Topic	Subframe Mount Control Unit - Calibration Update Bentayga Series 26-27MY (SC26/16)
Market area	Australia E04 Bentley rest Asia and Australia (6E04),Germany E02 Bentley rest Europe (6E02),Japan E03 Bentley Japan (6E03),United Arab Emirates E06 Bentley Middle East and Africa (6E06),United Kingdom E01 Bentley UK (6E01),United States E05 Bentley USA and rest America (6E05)
Brand	Bentley
Transaction No.	2082212/2
Campaign number	ED95
Note	
Type	
US code

Subframe Mount Control Unit - Calibration Update | Bentayga Series | 26-27MY
(SC26/16)

Release date: Aug 10,
2026

Figure 4

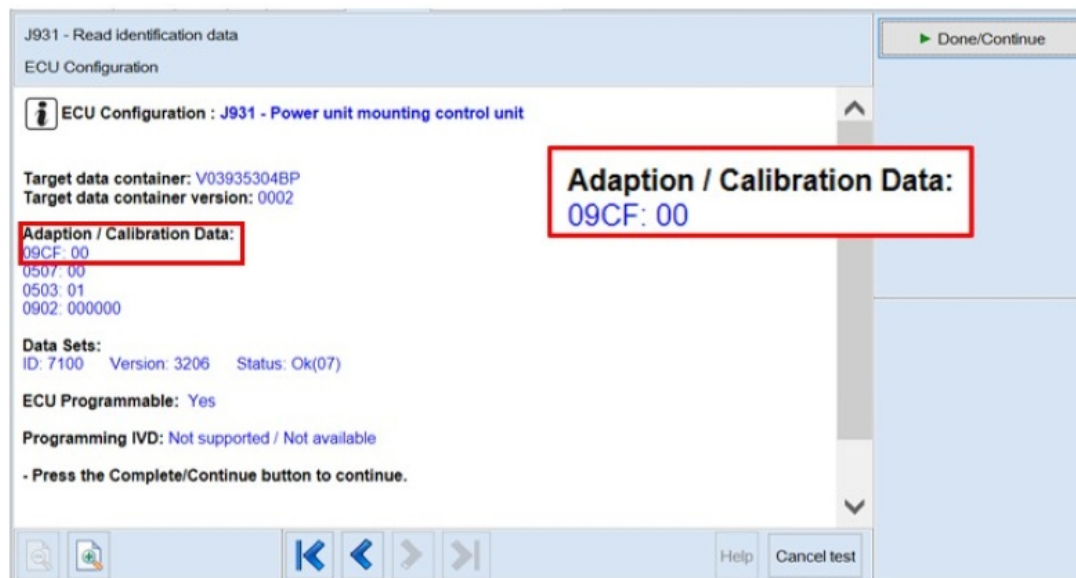
12. ECU Configuration After Update.

- Re-read control unit identification: TDC may still show same ID (this is acceptable).
- Check adaptation channel: 09CF must now be = 00 (previously 01).
